## SUNSHINE COAST REGIONAL DISTRICT

### Question and Answers # 2

Request for Proposal No. 2536503

Watermain Replacement North Pender Harbour

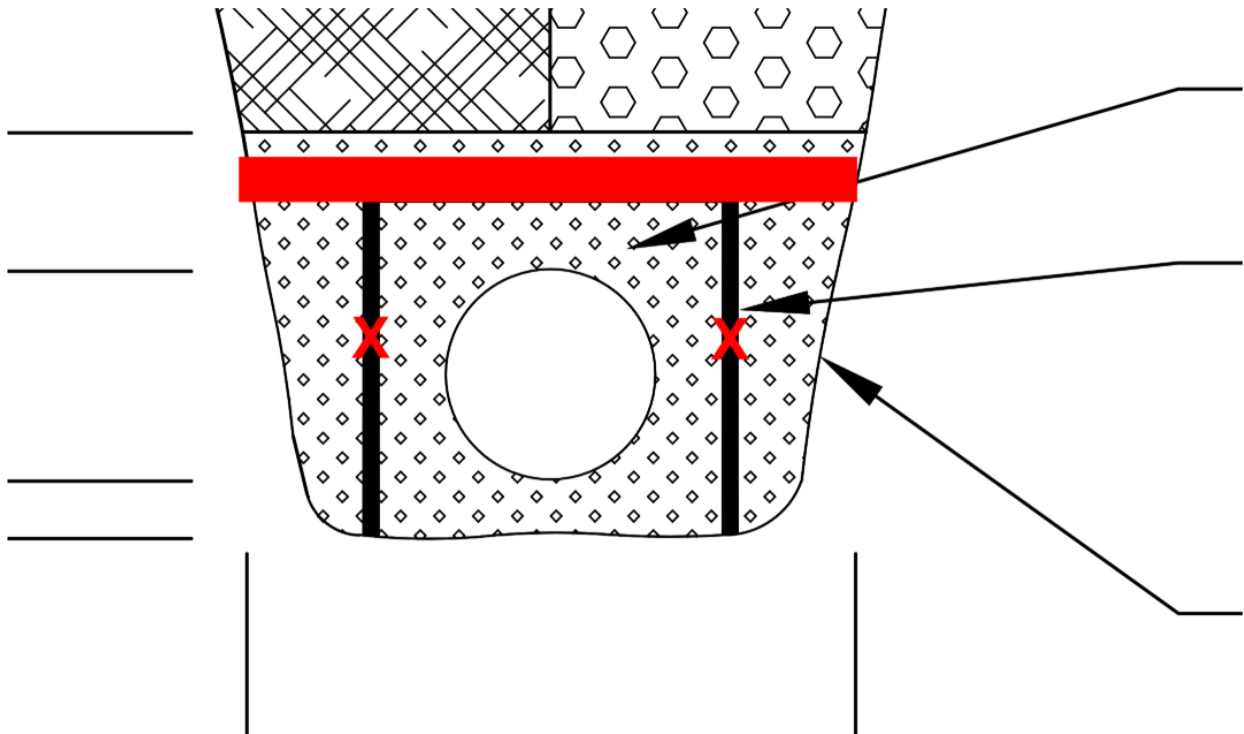
**Question:** Drawing C302 shows a pipe insulation detail. Could you confirm if this is required for the entire pipe length if 1m cover depths are achieved. The 3 sided insulation "box" looks like it would be difficult to construct and would affect the feasibility to compact the haunch zone of the 200mm watermain. If it is required, could this be replaced with a single sheet of rigid foam on top of the pipe. See markup below:

**Answer:** Insulated detail is required where the following can not be achieved "(g) Cover Minimum cover over the crown of ductile iron watermains shall be 1.0 M". - Bylaw 320. <https://scrd.ca/wp-content/uploads/2023/04/320-SCRD-Subdivision-Servicing-Bylaw-Consolidated-to-320.17-from-2022-SEP-08-to-Present-Schedule-B-Included.pdf>
